**Subject: Transmittal of the Responses to October 1, 2013 ACRS Comments on
GSI-191/LTCC**

**Responses to October 1, 2013 ACRS Comments on
GSI-191/LTCC**

**US-APWR Design Control Document
Mitsubishi Heavy Industries, Ltd.**

CHAPTER: 6
CHAPTER TITLE: ENGINEERED SAFETY FEATURES
DATE OF MEETING: 10/01/2013

Figure 1-1 Isometric Drawing of the Refueling Cavity Drain Line

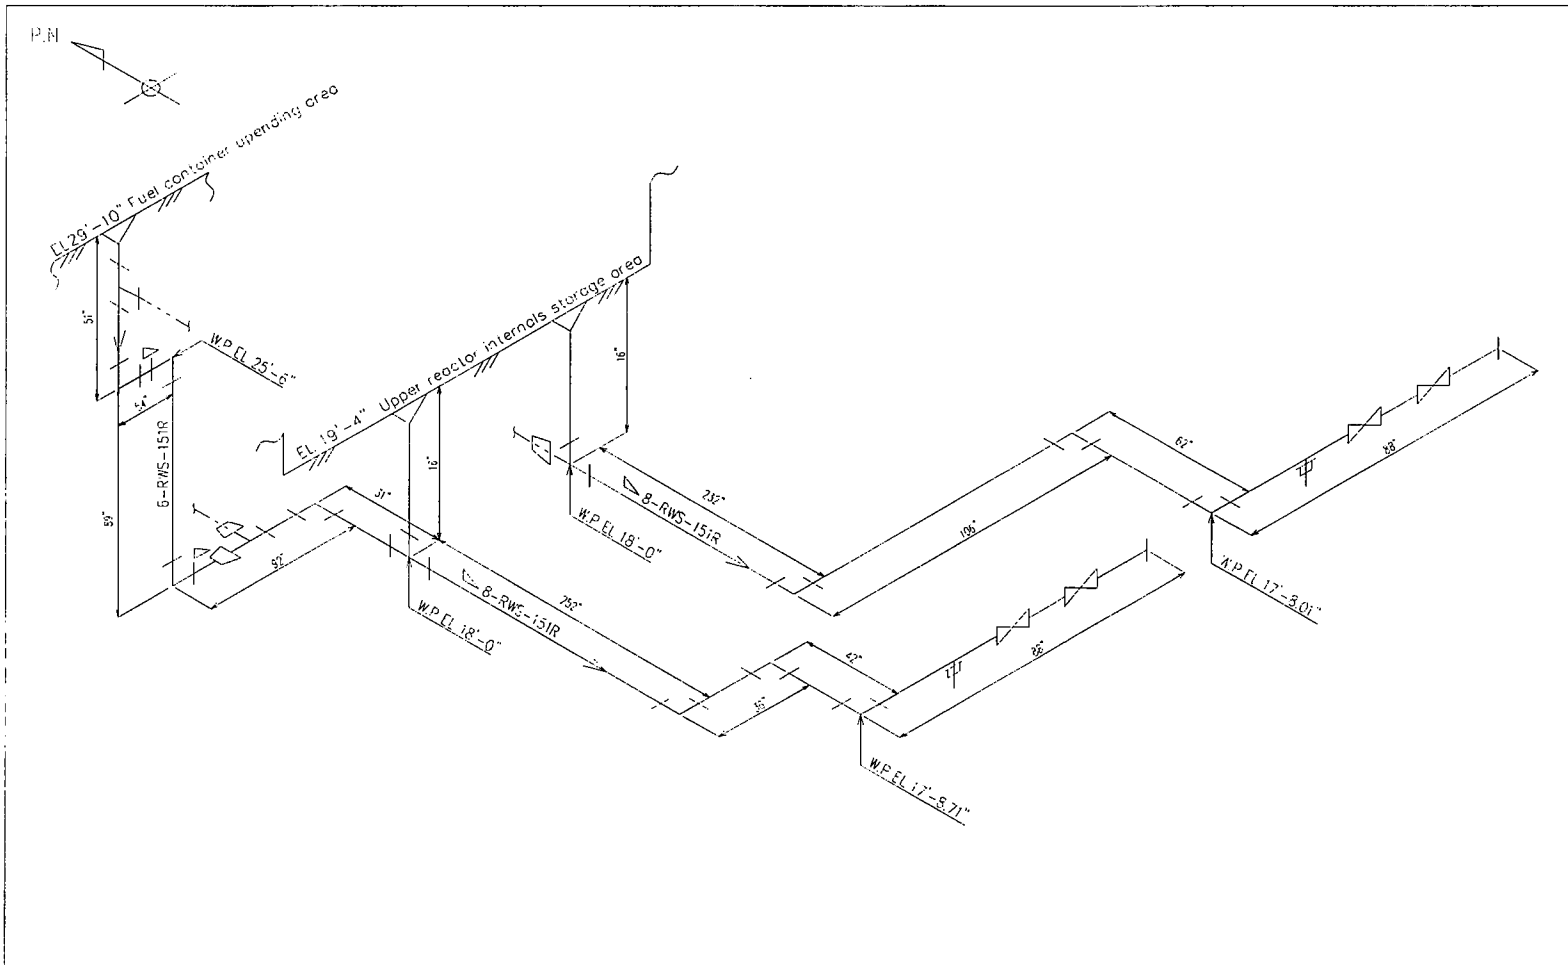
Check the design specification for the refueling cavity drain line and provide an explanation for why the line is not expected to be plugged up / clogged by debris.

MUAP-08001 "US-APWR Sump Strainer Performance" Section 3.7.1 identifies two possible choke points in the containment spray/blowdown return pathway for the US-APWR – the refueling cavity drain lines and the RWSP overflow lines. In both cases, the conclusion is that the lines will not be clogged by debris. The rationale for this conclusion with respect to the refueling cavity drain line is further explained below.

1. Debris Source for the Refueling Cavity Drain Line
For the US-APWR, the majority of debris will be generated in the SG compartments. There is no direct flow path between the SG compartments and the opening of the refueling cavity drain lines (two 8" lines), which are located at the bottom of the refueling cavity. Therefore, latent and miscellaneous debris are the primary type of debris that may be expected to reach the refueling cavity. However, grating with an opening size of 1" by 4" is arranged above the 8" diameter refueling cavity drain lines as shown in Figure 3-9 of MUAP-08001. This grating ensures that only "fine" and "small" latent fiber debris and particulate latent debris, which are smaller than 8" diameter, could reach the refueling cavity drain lines.

2. Refueling Cavity Drain Line Configuration
The refueling cavity drain lines have three upper sections one of which is located at the fuel container upending area on EL. 29'-10" and the other two are located at the upper reactor internals storage area on EL 19'-14". The line from the fuel container upending area and one of the lines from the upper reactor internals storage area merge to one line. The other line from the upper reactor internals storage area does not merge with the others. In other words, both drain lines are independently arranged with the lower ends draining to the Header Compartment area. (See Figure 1-1) The total length of the drain lines are approximately 60 ft and 42 ft, respectively, and both lines are arranged with approximately 1/100 slope.

The estimated minimum flow velocity is 0.85 ft/sec. With reference to NEI 04-07, the maximum fiber settling velocity for NUKON™ is 0.41 ft/sec for 6 in size, and its incipient tumbling velocity is 0.16 ft/sec maximum for a 1/4" by 1/4" clump. The 0.85 ft/sec estimated minimum flow velocity of the drain line is much higher than that of the NUKON™ fiber settling velocity and incipient tumbling velocity. Therefore, MHI concludes that there is a very small chance for the drain line to be clogged by debris in the line.

- As discussed in the item 1 above, the debris size which could reach those drain lines is expected to be smaller than the corresponding drain line inner diameter.
- As discussed in the item 2 above, the drain lines are relatively short and are sloped.
- As discussed in the item 3 above, the estimated minimum flow velocity of the drain line is much higher than the NUKON™ fiber settling velocity and incipient tumbling velocity.

Figure 11-1 Plant Elevation Associated with Water Level for Minimum Water Level Calculation

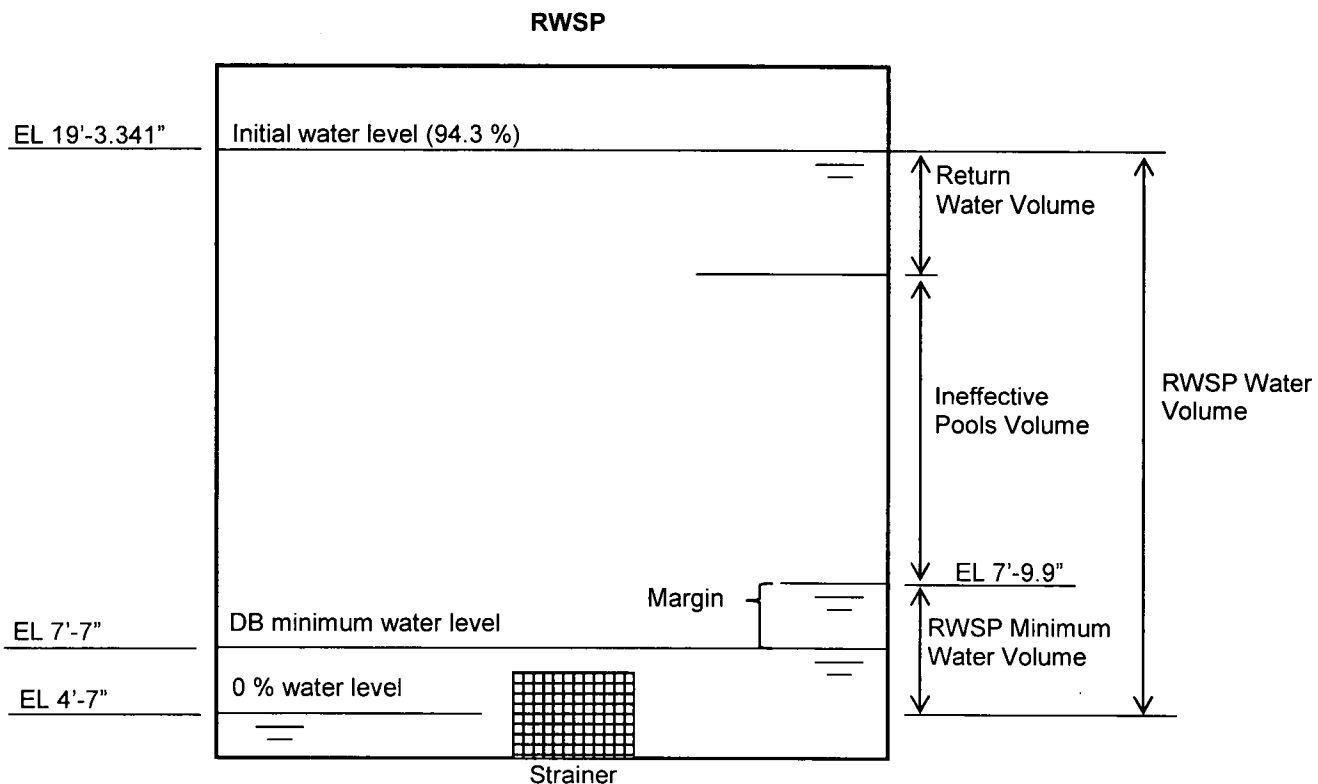
Annotate Slide 58 to show the plant elevation associated with each RWSP level depicted on this figure.

The requested evaluation information has been added to Figure 11-1. It is noted that the volumetric relation is provided in Figure 3-11 of MUAP-08001 "US-APWR Sump Strainer Performance".

Figure 12-1 NPSH Available vs. Time

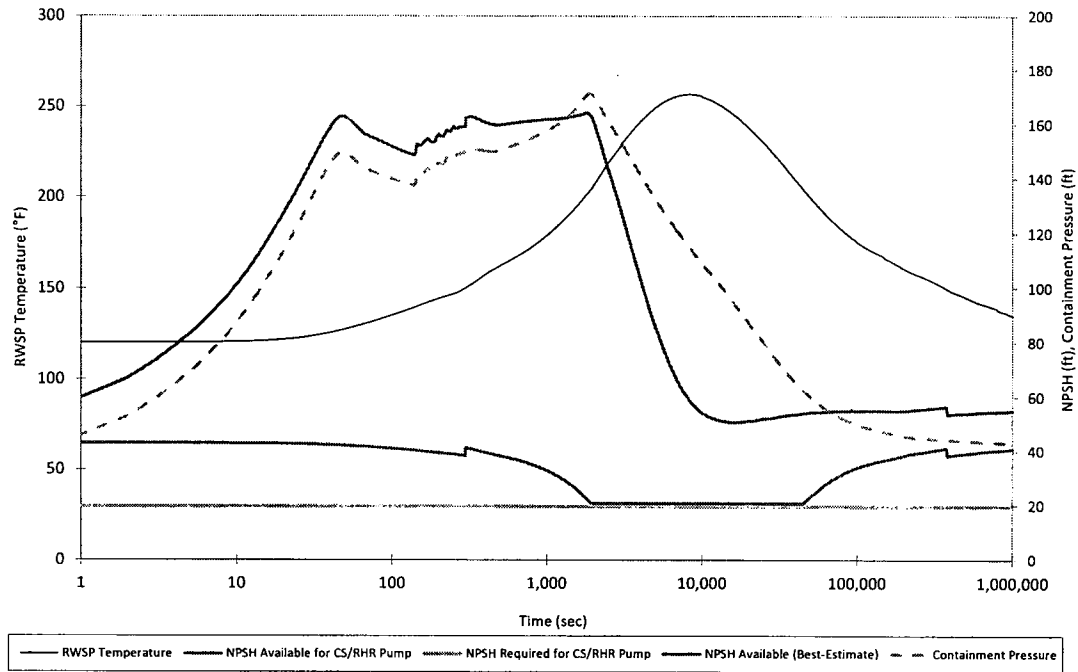
Supply an expansion of the plot given in Slide 61 over the first however long that time period is, 20 to 30 hours, to show in detail how the NPSH available versus NPSH required varies in a realistic analysis. Provide an expanded view of the plot on Slide 61 for the first 12 hours of the transient for both the realistic analysis and the limiting case.

Figure 12-1 show the expanded view of the plot of NPSH available vs. time for the first time range. In addition, plots of best-estimate NPSH available and the containment pressure are added to this figure.

NPSH available (design-basis) decreases at approx. 30 minutes (1,800 seconds) due to the increase of the RWSP fluid temperature. When the RWSP water temperature exceeds approximately 212°F, the NPSH available for the design-basis is assumed constant because of the assumption that the containment pressure equals to the saturation pressure of the RWSP water temperature. After the RWSP temperature drops below approximately 212°F, NPSH available increases due to the RWSP temperature decrease. In this figure, there is a little margin between NPSH available (design-basis) and NPSH required during the RWSP temperature above 212°F, but there is more than 1 feet margin as shown in Figure 3-17 and Table 3-11 of MUAP-08001.

On the other hand, the increase in NPSH available (best-estimate) at 30 minutes corresponds to the increase in the containment pressure. Since the NPSH available (best-estimate) is much larger than the NPSH available (design-basis) during the period of time when the RWSP temperature is over 212 °F, it is concluded that MHI's current evaluation of NPSH available (design-basis) has sufficient margin and is sufficiently conservative.
